The Commission has issued the enclosed Amendment No. 66 to Facility Operating License No. DPR-65 for Millstone Nuclear Power Station, Unit No. 2. This amendment consists of changes to the Technical Specifications (TS) in response to your application dated September 16, 1980.

SUBJECT: NORTHEAST NUCLEAR ENERGY COMPANY, ET AL., MILSTONE NUCLEAR POWER  
STATION, UNIT NO. 2

Amendment No. 66  
License No. DPR-65

ATTACHMENT TO LICENSE AMENDMENT NO. 66

Figure 6.2-2 Facility Organization - Millstone Nuclear Power Station - Unit 2.

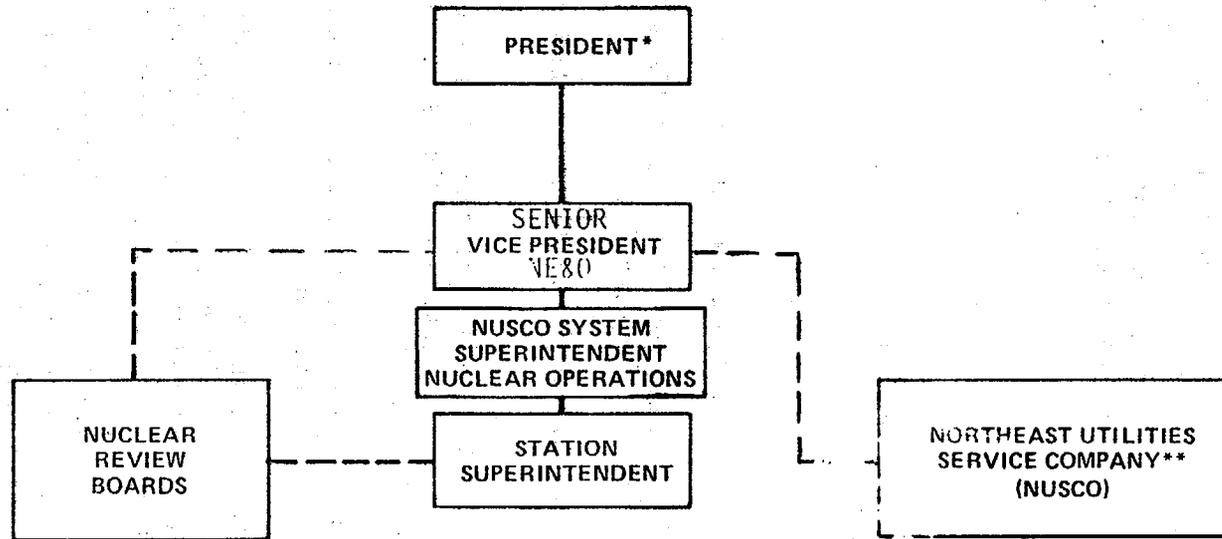
6.2.2 The Facility organization shall be as shown on Figure 6.2-2 and:

Our request indicated that the TS related to minimum shift manning should be revised to reflect the augmentation of Shift Technical Advisor. The licensee's application would add one Shift Technical Advisor to each shift to perform the function of accident assessment during reactor operation. The individual performing this function will have at least a bachelor's degree or equivalent in a scientific or engineering discipline with special training in plant design, and response and analysis of the plant for transients and accidents. Part of the Shift Technical Advisor duties are related to operating experience review function. Based on our review, we find the licensee's submittal satisfies our requirement and is, therefore, acceptable.

Figure 6.2-1 Offsite Organization for Facility Management and Technical Support

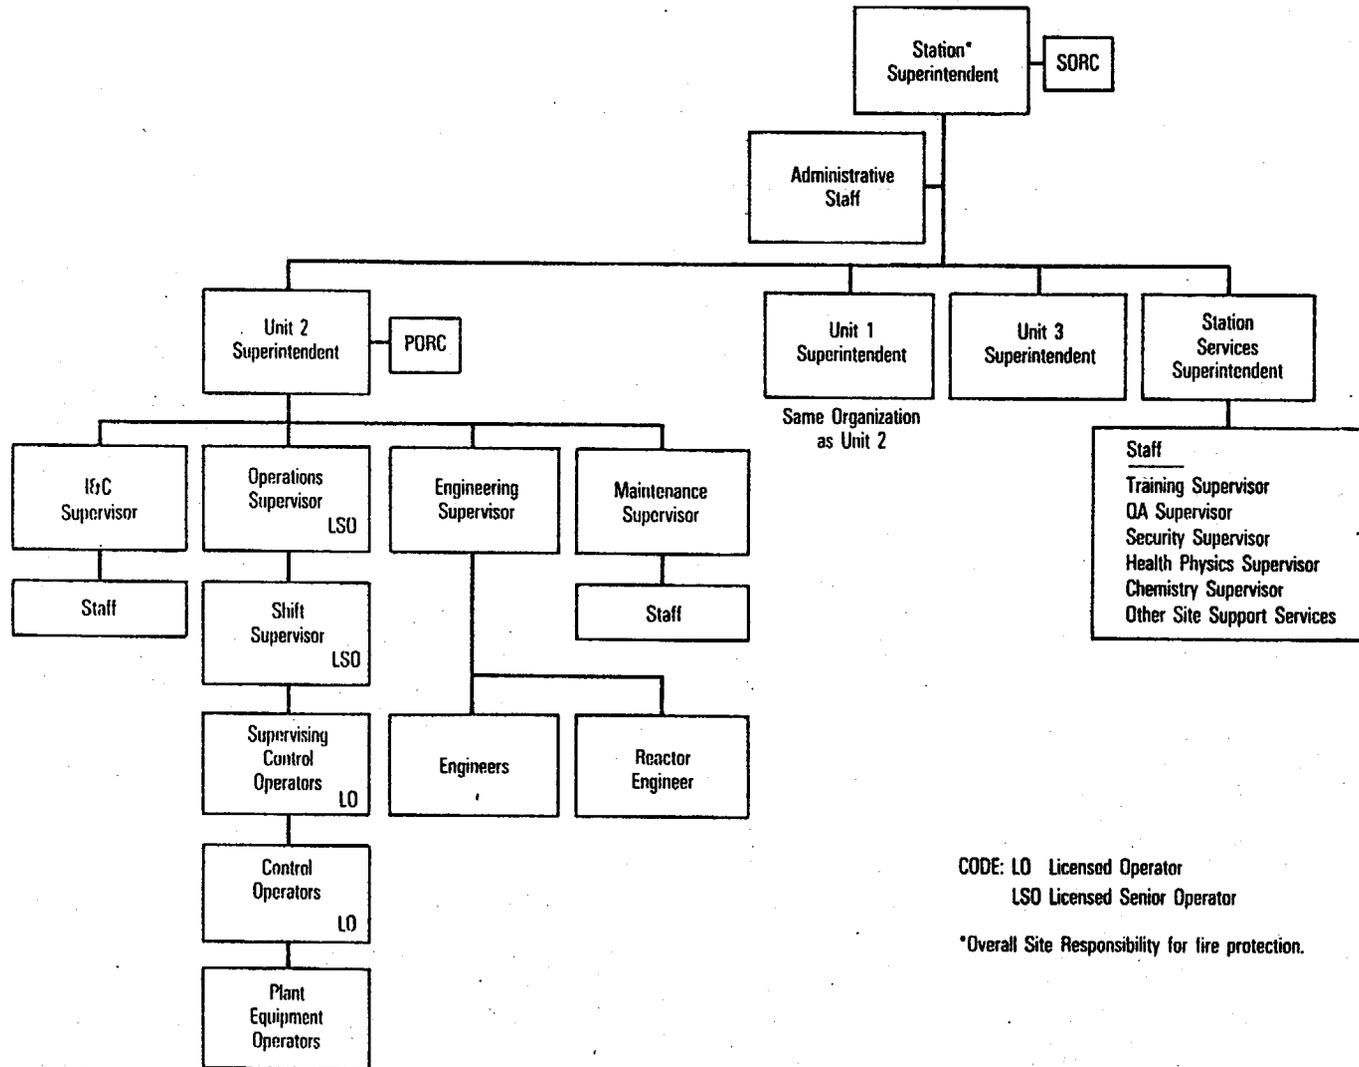
6.2.1 The offsite organization for facility management and technical support shall be as shown on Figure 6.2-1.
